UNITED STATES PATENT AND TRADEMARK OFFICE

APPLICATION NO.	FILING DATE	FIRST NAMED INVENTOR	ATTORNEY DOCKET NO.	CONFIRMATION NO.
10/629,043	07/28/2003	Mark Alan Littell	Littell	7395

Office Action Summary	Application No.	Applicant(s)	
	10/629,043	MARK LITTELL	
	Examiner	Art Unit	
	Shumaya B. Ali	3743

DETAILED ACTION

Prior Art
U.S. Patent
5,479,941

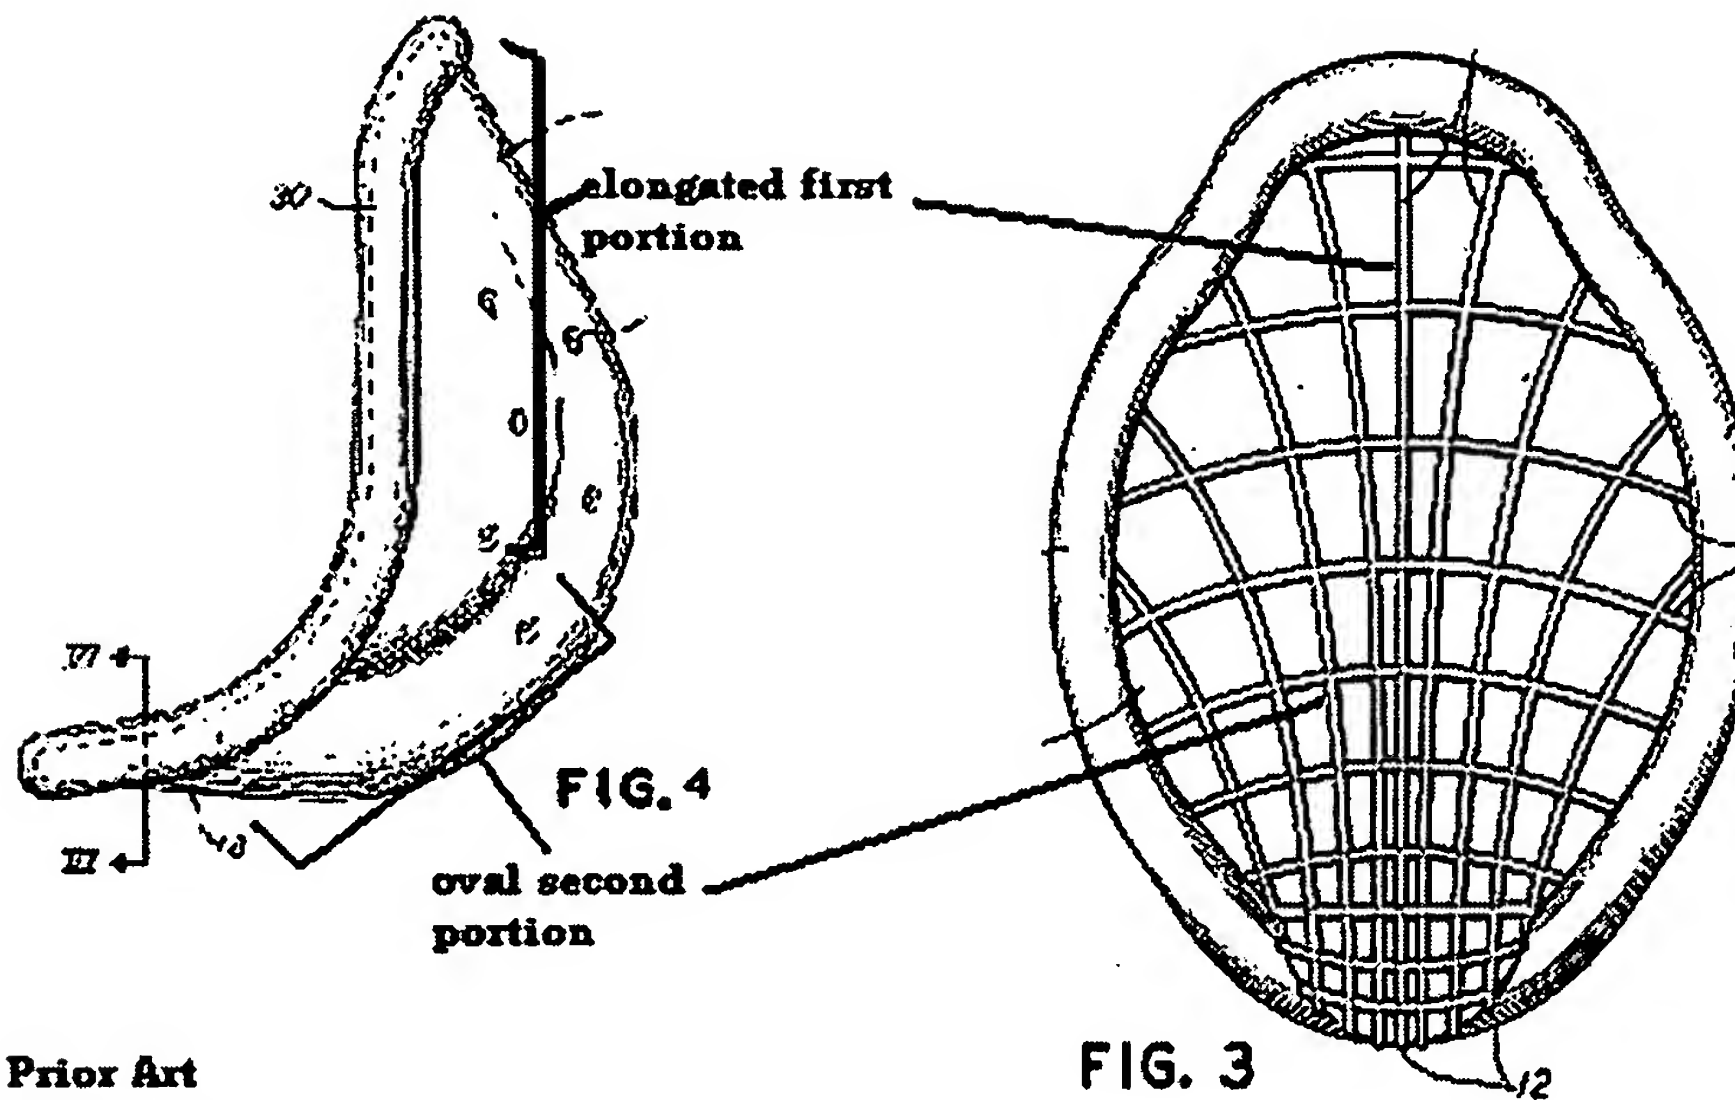
5. As to claim 1, DiMatteo discloses a system for protecting a male genital region from injury in addition to providing comfort to a wearer (see col.2 lines 62-67, col.3 lines 1-2) including a cup (see fig.1 reference object 10) with elongated first and oval second portion (see labeled figs. 3 and 4, attachment

6. **As to claim 2, DiMatteo discloses** the protective device of claim 1 wherein said first portion is positioned above said second portion (see figs. 3 and 4, the elongated top portion is positioned above the oval bottom portion).

7. **As to claim 3, DiMatteo discloses** the protective device of claim 1 further comprising a flange (extension rod with finger like projection) positioned (see fig.5 reference object 16) at the lower end of the protective device (lower end of the oval portion, see labeled figs.3 and 4), **however does not disclose the flange facilitates securing the protective device to the male body to minimize horizontal and vertical movement.** Notice, however, the finger like extension is designed to extend between the wearer's upper thighs, and engage his body proximate to the superior ramii, the inferior ramii, and/or the Ischial ramii of the pelvis with minimal contact with the upper thigh (see col.6 lines 23-27). Additionally, the rod is larger dimension in the vertical direction as opposed to the horizontal direction (see col.6 lines 38-41). The position and the size of the exertion rod with finger like projection inherently capable of preventing the cup from dislodging by minimizing horizontal and vertical shifts. Therefore, it would have been obvious to one of ordinary skills in the art at the time of invention that a flange or a finger like extension of a cup that is long
